Docket Item # 15  
BAR CASE #2008-0008

BAR Meeting  
February 6, 2007

**ISSUE:** Additions and alterations

**LOCATION:** 5 Potomac Court

**Figure 1** - Proposed north elevation

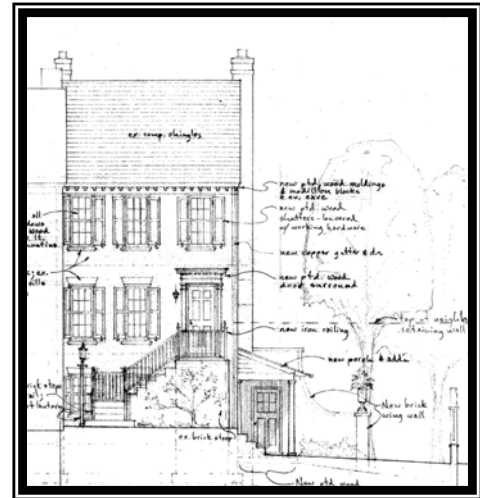
Front (north) elevation - All windows on the front elevation are proposed to have new wood louvered shutters. The shutters will be sized to fit the openings and will be operable. The easternmost shutters will not open fully due to the lack of space between 5 Potomac Court and its neighbor. These shutters will rest against the west wall of the adjacent house. A new painted wood door surround with a dentiled cornice is proposed..

1. The stucco color must be submitted to Staff for review and approval;
2. Shutters are not to be installed on the north or south elevations;
3. The brick garden wall proposed to be installed near the property line adjacent to Windmill Hill Park is to be a maximum of 6' in height on the side facing Windmill Hill Park from the existing topographic grade; and,
